Harding Lawson Associates

NMD000804292
Request for Determination
Revised Permit Application
Safety-Kleen Corporation
Albuquerque Service Center

**TABLE 1
SAFETY-KLEEN
ALBUQUERQUE SERVICE CENTER
REQUESTED CLASS 1
PERMIT MODIFICATIONS**

**TABLE III
SAFETY-KLEEN
ALBUQUERQUE SERVICE CENTER
REQUESTED CLASS 3
PERMIT MODIFICATION**

INTERIOR OF CENTER TRENCH (OUTLET PIPE TO FIREWATER CONTAINMENT TANK AT LEFT. INLET PIPE FROM SOUTH DOOR TRENCH AT RIGHT) (PICTURE TAKEN PRIOR TO MODIFICATION OF OUTLET PIPE)

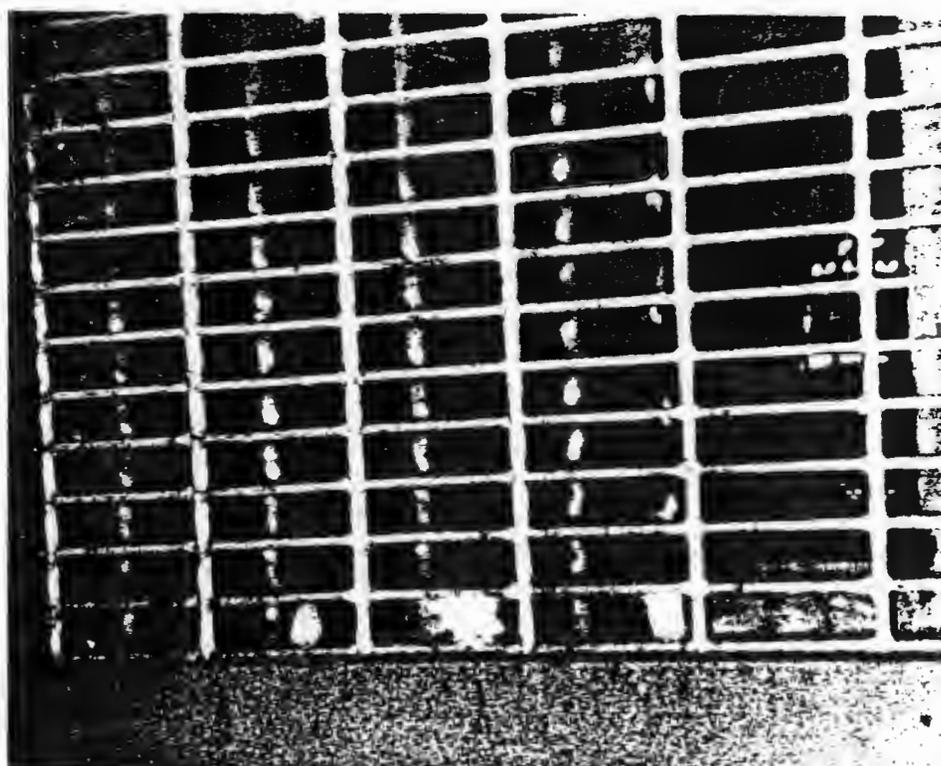
Inspection by TERA on April 9, 1992 revealed that the outlet pipe from the center trench was not installed above the door trench pipes as designed (See Plate 4 and Photo B on Plate 18). The contractor corrected this deficiency during April 10-13, 1992 as shown on Plates 8 and 19. A 90-degree elbow was installed to elevate the mouth of the center trench outlet pipe above the entrances to the door trench outlet pipes. A square of sheet metal was fastened to the underside of the grate to cover the open mouth of the pipe, which now faces upward. Thus, the firewater collection tank remains isolated from a potential 10% hazardous waste spill within the warehouse. With these modifications, the H-3 Building's secondary containment now appears to satisfy the design requirements of HWMR-6, Pt. V, sec. 264.175 (b)(2).

OUTLET PIPE (AFTER MODIFICATION) FROM CENTER TRENCH
TO FIREWATER CONTAINMENT TANK
